Written Submission to Committee of the Whole (Public Meeting), March 2, 2021, Item 5 – 72 Steeles Ave West & 7040 Yonge Street

Respectfully submitted by Jordan Max, President of the Springfarm Ratepayers Association

Figure 7: Concept Plan (Architectural Drawings, p. 12) superimposed on Schedule 2 of Secondary Plan green space location

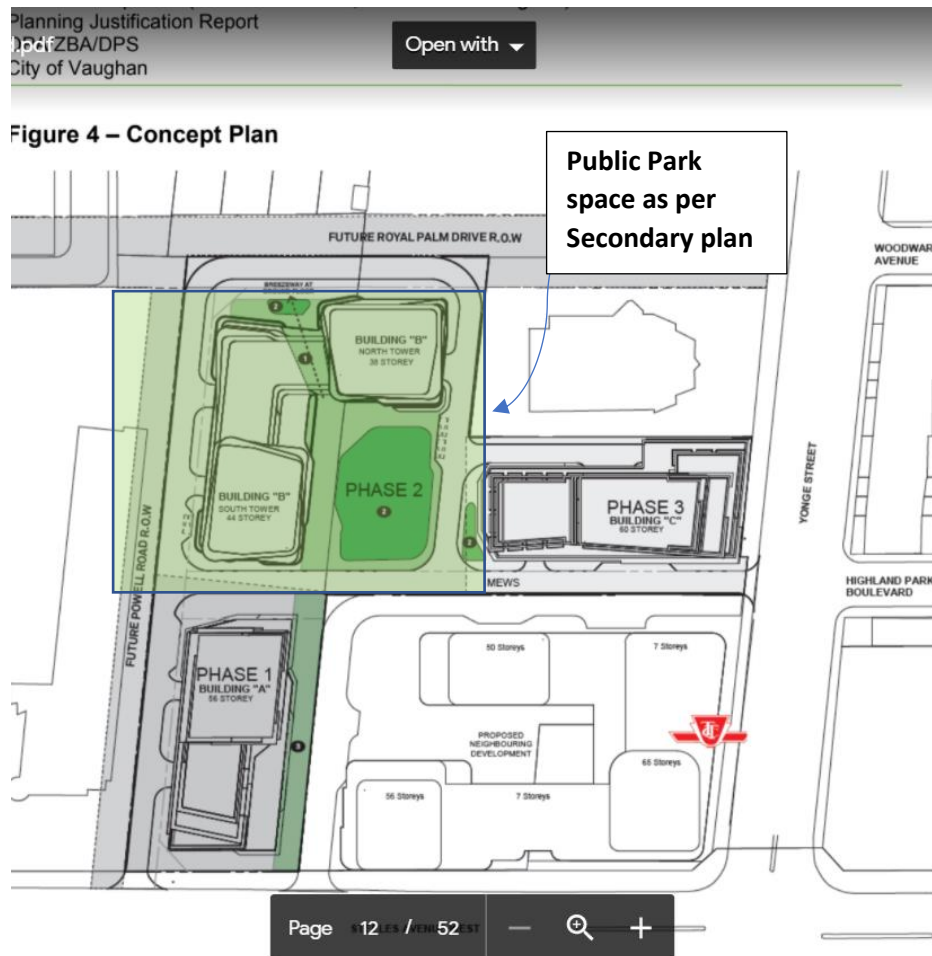
So it would appear that the developer generally supports the Yonge Steeles Corridor Secondary Plan. However, most significantly, as Figures 5, 6 and 7 illustrate, the developer has actually proposed to build two buildings on three-quarters of the largest designated green space in the entire Secondary Plan. **This is an unconscionable appropriation of critically necessary, designated “land to be conveyed to the City for Park Purposes” (ie. Park)** as a “Private-owned Publicly accessible Space” (POPS), which will only be built during Phase 2 (Building B, with the 38 and 44 storey tower on top of a 12-storey podium. So there will be zero provided green space at grade for the occupants of the first buildings. And no public park. This is appropriation of public space for private use, which must be vigorously challenged.

Figure 8: Site Setbacks – Building B North Tower (Source: Architectural Drawings, p. 7)

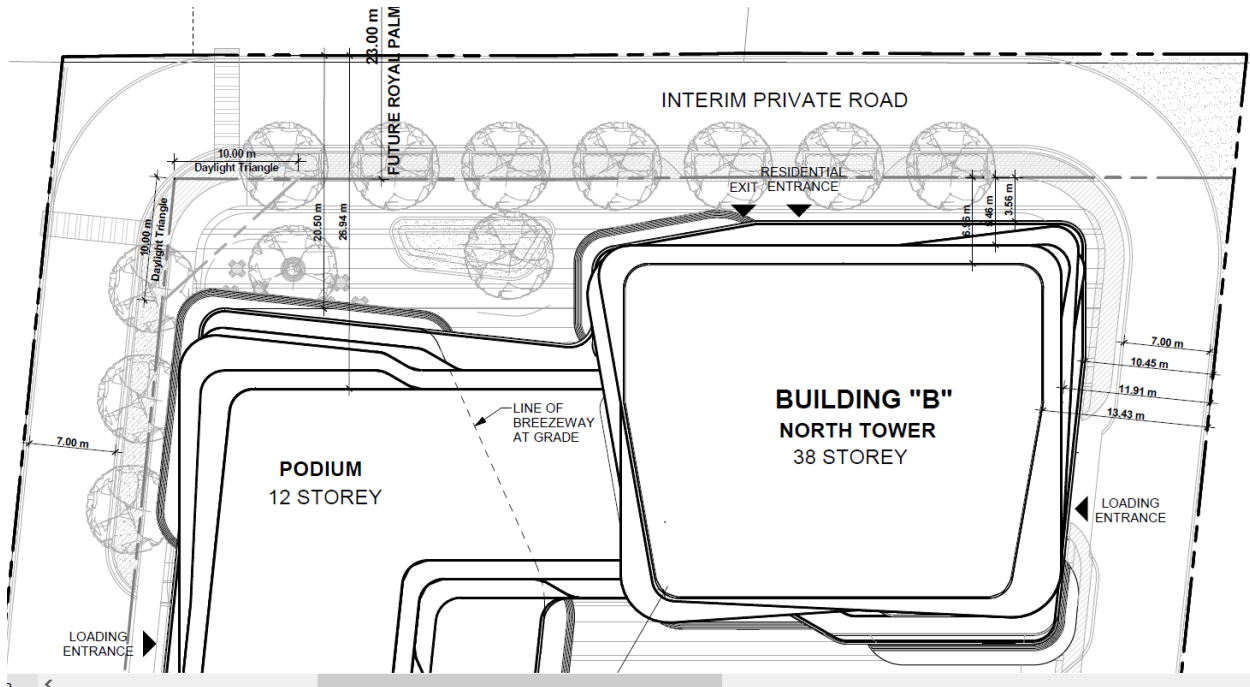
As illustrated by Figures 8, 9, 10, and 11, the site appears to have a 7m setback for the private interim road, and small setbacks between the road and the building perimeter. (The Zoning by-law requires a 7.5m setback for an RA3 apartment zone, and half of the height where a building exceeds 11m in height).

We also note that Humboldt has chosen to build only interim private roads around the northern and western perimeter of the site. Thus, the outside edge of the private road is considered to be the property line. Whereas were Humboldt to build the permanent Right of Way for Powell and Royal Palm, the inner edge of the road would become the property line, and therefore the setback to the building perimeter would start there. So, in reality, the setbacks, even though less than the minimum requirement of the Zoning By-Law for an RA3 Apartment zone, the building perimeter should actually start at least 10 m further inside the property, which would constrain the building footprint.

The fact that the developer chose to build on a small, narrow parcel of land on the western side does not mean that they can skirt around the City's required setback requirements by delaying the construction of the Powell and Royal Palm extensions until the adjacent property owners agree.

Figure 12 Privately-owned publicly accessible spaces (source: Architectural Drawings set, p.7)

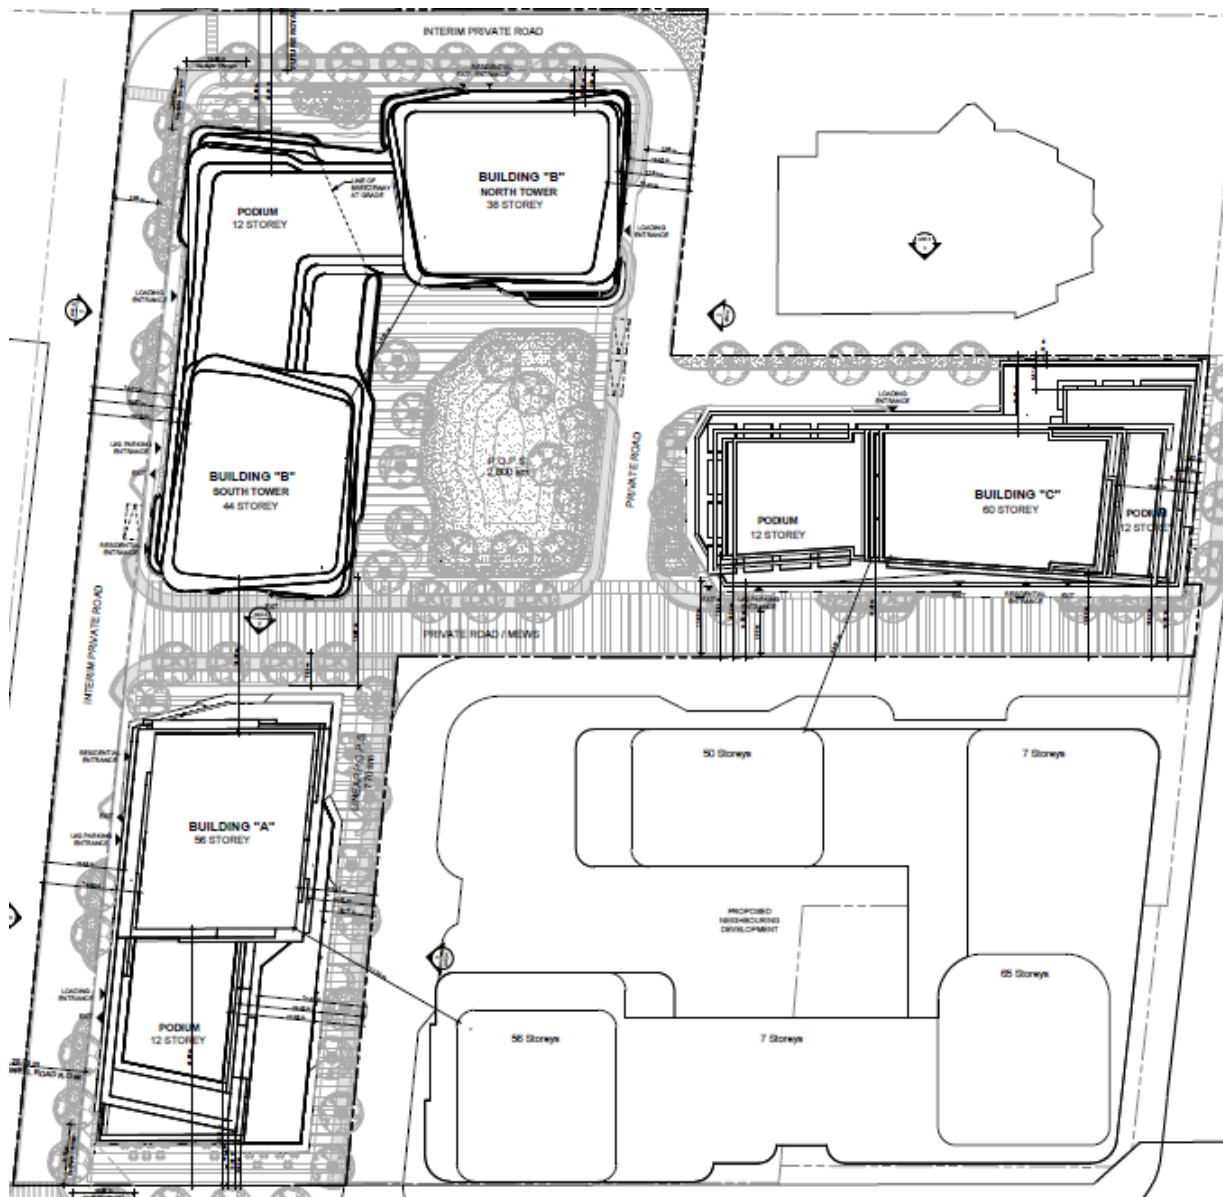
Figure 12 illustrates that there is 3,570m² private accessible open space (POPs), however 78% of that is taken up by the central private green space. Setbacks from roads are all less than the 7.5m required by the Zoning By-Law for an RA3 High Rise Apartment Zone.

Figure 15: Western boundary setbacks (source: Architectural drawings, p. 29)

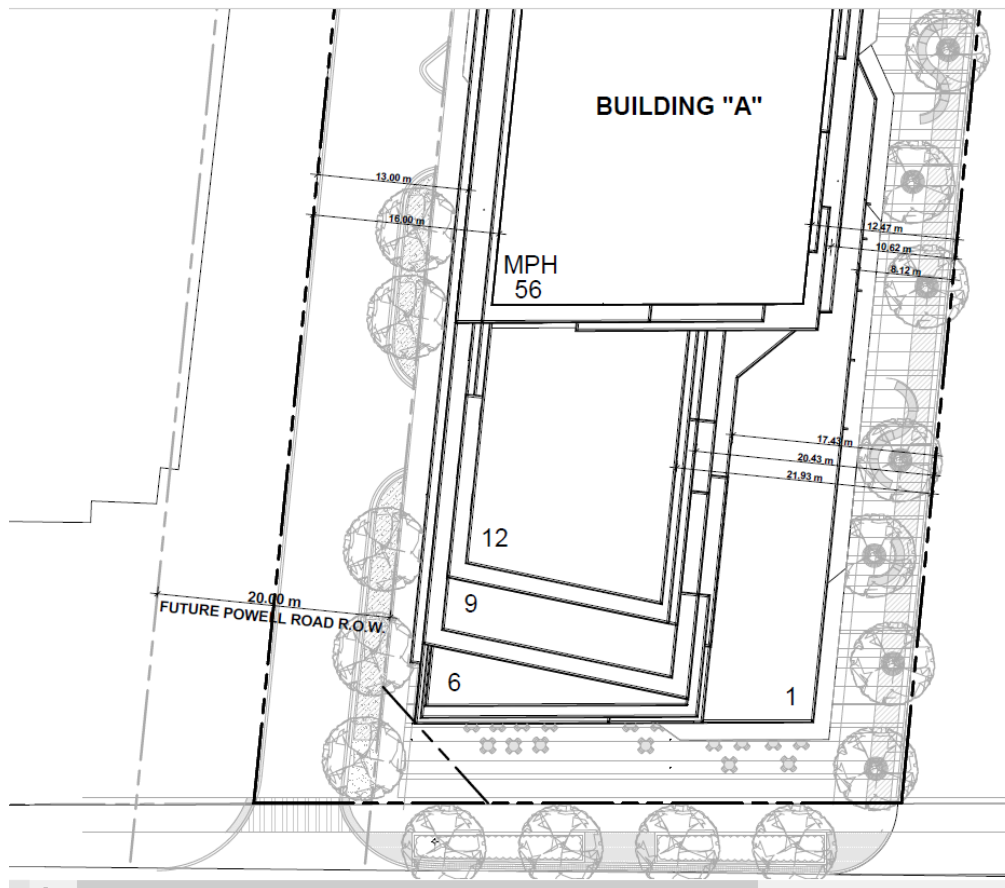
We note, as shown in Figure 15 that the 20m ROW demarcation for Powell (which should be 23m) actually intrudes onto the Sisley Honda property, and since Sisley is not included in this proposal, they cannot be expected to demolish the eastern wall of their building for the ROW. So it is only appropriate that the ROW be entirely within the Humboldt property, which would push the ROW eastward by at least 3 metres for the required ROW, plus another 1 or 2 metres to allow for sidewalk and setbacks to the building edge.

Figure 16: Composite illustration of overlap between 7080 Yonge and 72 Steeles Ave W sites

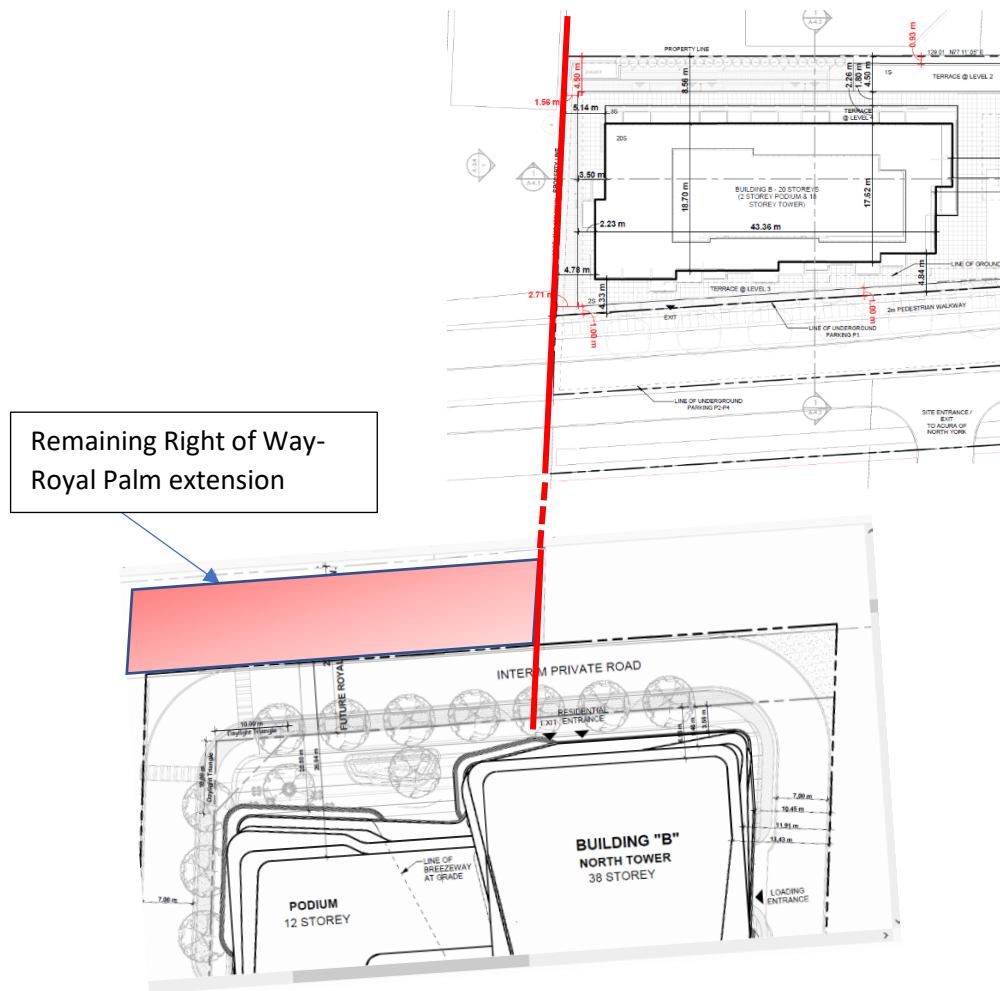
With respect to the Royal Palm extension, as shown in Figure 16, there is a discrepancy between this proposal and the one from 7080 Yonge Street, which is northeast of this site. For 7080 Yonge Street, the developer, Chestnut Hill, has proposed to both convey and construct the portion of Royal Palm, in its full width Right of Way (23m wide) from Yonge Street to the western edge of its property. As illustrated in Figure 16, the western end of 7080 Yonge Street meets the mid-block of the Humboldt site (shown by the red line). Yet, Humboldt does not intend to construct the full width Right of Way from that point to the western end of its property, but to only build a private, interim road of 10m width. Thus, the Royal Palm extension would be 23m wide from Yonge Street to the western end of 7080 Yonge, and then abruptly shrink to only 10m width from that point westward, where it would join up with the private interim Powell road. This is a clear example of the lack of integration and co-ordination of the Humboldt project with adjacent projects. Simply put, we believe that Humboldt must at least convey the full 23m width Right of Way for Royal Palm from the western boundary of the 7080 Yonge Street site to the western end of the Humboldt site. The remaining section is shown in a red shaded box in Figure 16.

Figure 18: Angular plane renderings from the northwest, source: Architectural Drawings, p. 35)

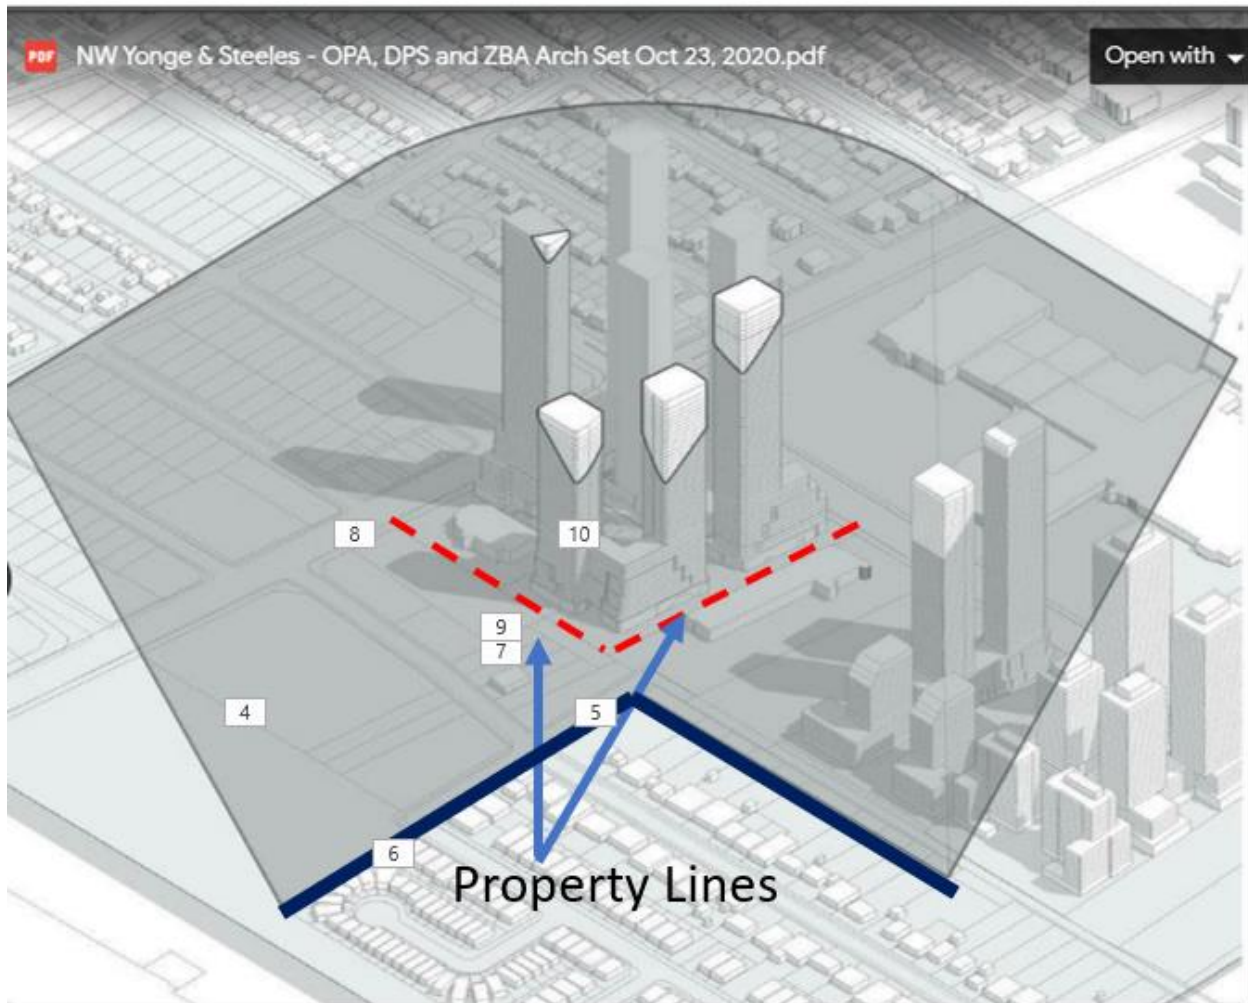
The architect has supplied a 3D schematic shown on page 35, (Figure 18) but the only point of origin appears to be the northwest corner of the site (shown in heavy dark blue lines), taken from the opposite side of the Powell Road extension, and not on the rear property line (the eastern edge of Powell Road) (marked in dashed red lines). The architectural drawings do not illustrate the 45-degree angular plane originating from the rear property line required in the City's Design Review Guidelines (see Figure 17) to transition to the residential neighbourhood to the west. We also note that the architect has chosen to exclude the 7080 Yonge Street rendering on the northeastern side of the property.

We submit that the 45-degree angular plane must be illustrated along every property line on the western and northern site boundaries, which are adjacent to low-rise residential areas. Given that the setback on the northern boundary is a maximum of 10m, a 45-degree angular plane would undoubtedly intersect at 10 metres, (e.g. a 3-storey podium), and thus if continued upward, it would require a substantially greater setback from the podium to the tower. However, since the architectural drawings do not show the 45-degree angular plane from the

Figure 23 – Shadow Study- March/September (source: Architectural drawings, pp. 32)

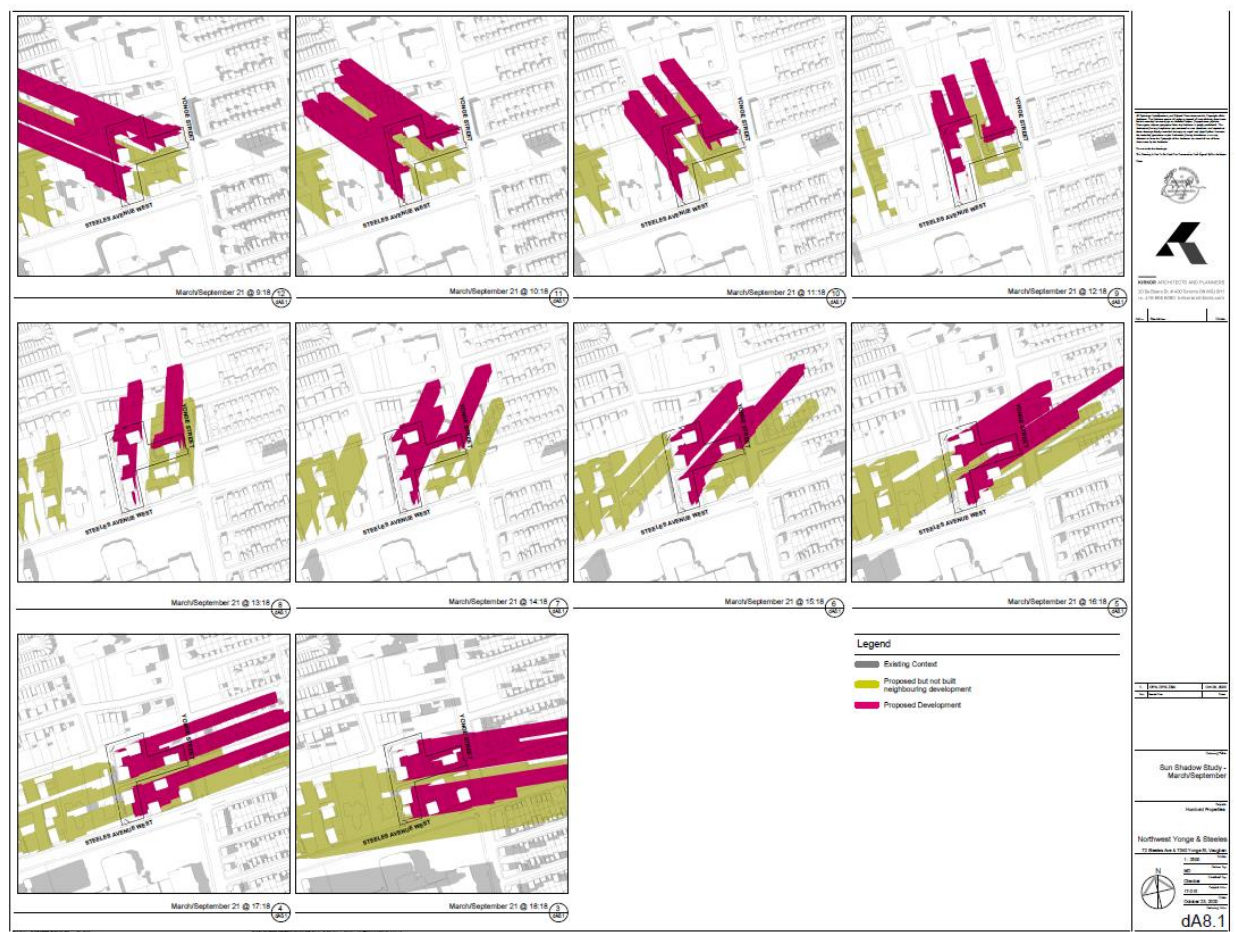
Shadows accrue from building height, massing and siting. The shadow study included in the Urban Design Brief (p. 59) shows (see Figures 23, 24, and 25) the Humboldt buildings' shadows in red, and the other buildings in the area (Gupta and Salz) in green. We note that the much-vaunted green space in the center of the proposal will be shaded for 23 of 24 hours of the day for much of the year, due to shadowing from Building 1 as well as the three proposed Gupta towers. This demonstrates a lack of integration and co-ordination between the Gupta and Humboldt projects, which will need to be resolved. Significant shadowing across the eastern side of Yonge Street in Markham must also be addressed. The simplest solution is to reduce building heights and the number of buildings.

approximately half of the northern edge of the Humbold property faces the Chestnut Hill project, we would expect to see more visual connectivity as well, so that Chestnut Hill does not appear as a separate island. The northeastern face of the North tower of Building B is essentially a solid block, with minimal (3.56m) setback, and this would no doubt be visually unappealing and shadow-inducing to the Chestnut Hill residents. As the last proposal for the Yonge-Steeles area submitted to date, it is incumbent on Humbold to take into full account the cumulative impact of all of the preceding proposals and to address them head on. We doubt that there is a “project firewall” in the architect’s office between adjacent projects under development at the same time.
